Retrofit Emission Control Devices (REC)

Proposal for an amendment to Regulation No.[..]

Submitted by the chairman of the informal working group on Retrofit Emission Control devices (REC)

Draft rev.01 Version 4 dated 20.02.2013

Annex 3.

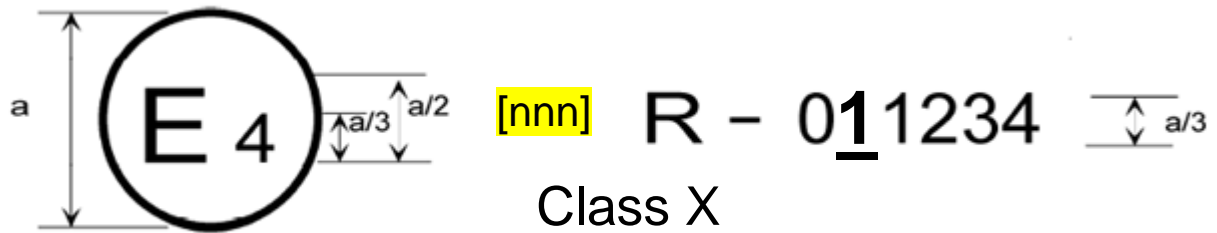
Annex 3 is replaced by

The above example approval mark affixed to a REC shows that the type concerned has been approved in the Netherlands (E 4), pursuant to Regulation No. [nnn] under approval No. 0011234. The first two digits of the approval number indicate that the approval was granted in accordance with the requirements of Regulation No. [nnn] ~~in its original form~~ **in the form as amended by this revision.** The approval mark shall also show the Class of REC (I, II, III or IV)
